COTTAGE GROVE CITY COUNCIL
12800 RAVINE PARKWAY SOUTH
COTTAGE GROVE, MINNESOTA 55016
COUNCIL CHAMBER - 7:00 PM

September 17, 2025

Staff Recommendation: 1) Adopt Resolution 2025-144 approving a Site Plan Review for a building addition, façade remodel, and exterior site improvements at Park Grove Library. 2) Adopt the Development Agreement with Washington County, subject to minor modifications as approved by the City Attorney.

1 BITUMINOUS PAVEMENT (HADLEY AVENUE)
C5.002 NOT TO SCALE

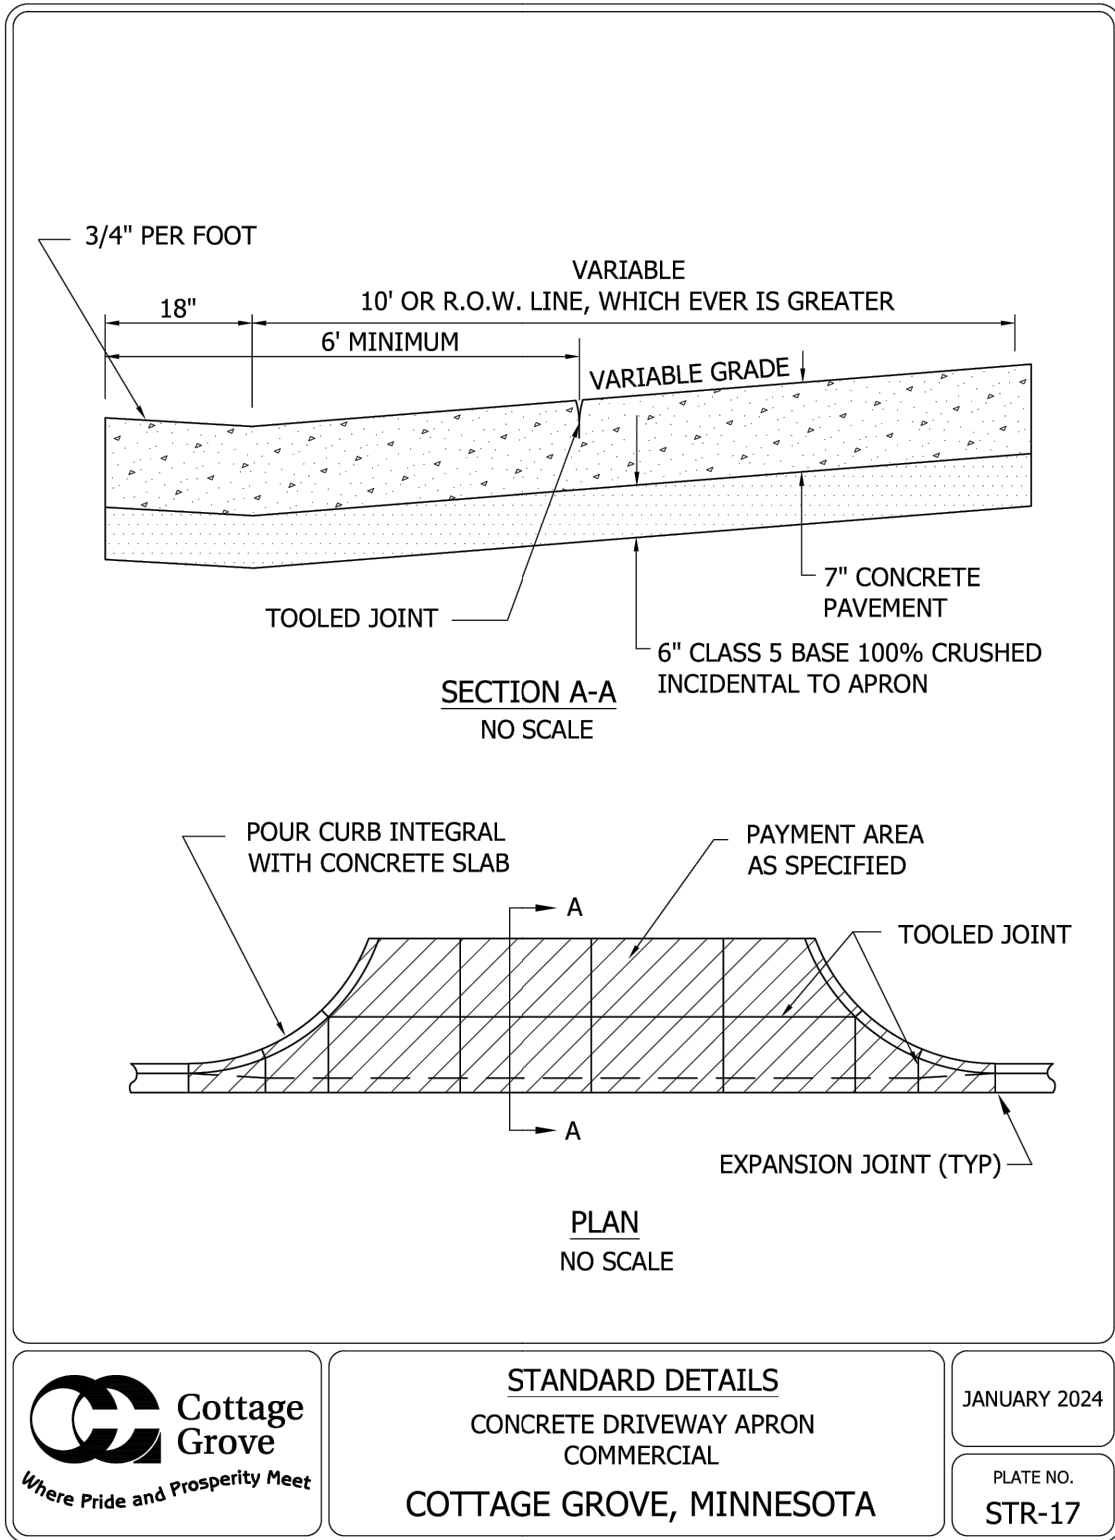
1. With the proposed apron replacement on Hadley Avenue, a mill/overlay to centerline of the roadway will be required per city detail STR-21.
 - a. Please include city detail STR-21 on Sheet C5.002 (but labeled C5.001 in the submittal) and remove detail STR-17.
 - i. There are currently two sheets numbered C5.001; please revise the second to C5.002.
 - b. The wear course of the mill-overlay section should be specified as SPWEA340C.
 - c. Any impacted striping will need to be replaced.
